AGENDA

Clinton City Planning Commission

DATE: 06/29/2016
TO: Will
FROM: Gregg Folk
RE: Stonegate phase 2 and 3

DATE: 6/8/2016
TO: Will
FROM: Gregg Folk
RE: Harrisburg phase 6 - 7

STONEGATE
A PORTION OF THE NE1/4 OF SECTION 29, T5N, R2W, S18&M
CLINTON CITY, DAVIS COUNTY, UTAH

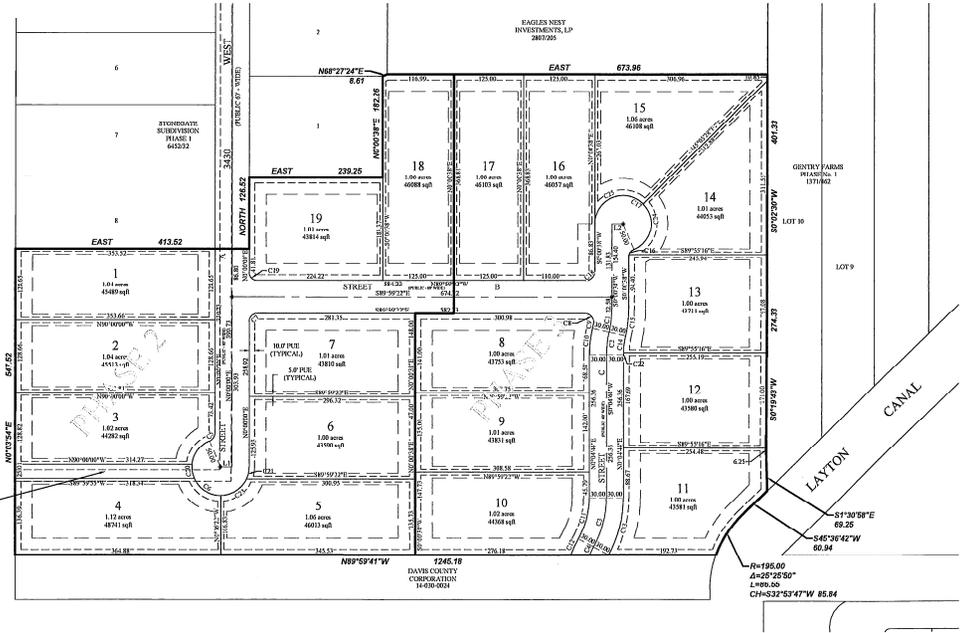
- Contractor to install all traffic signage per MUTCD
- Put address signs on stop sign pole
- SS on 3430W is existing district main
- Ada ramps per Clinton City standards
- Street plan to show 10" of roadbase
- Pp02 sewer info is wrong
- Provide description and use of Parcel a
- Pp03 verify SD size per SD calculations
- Pp04 show inlet 103 connection to 102 on profile
- Pp04 add valve on culinary main on street C at station 1200
- Other than 3430W, use Clinton City street section
- Pp06 add a street light on west side of road at canal
- Pp06 call out utility connections at canal
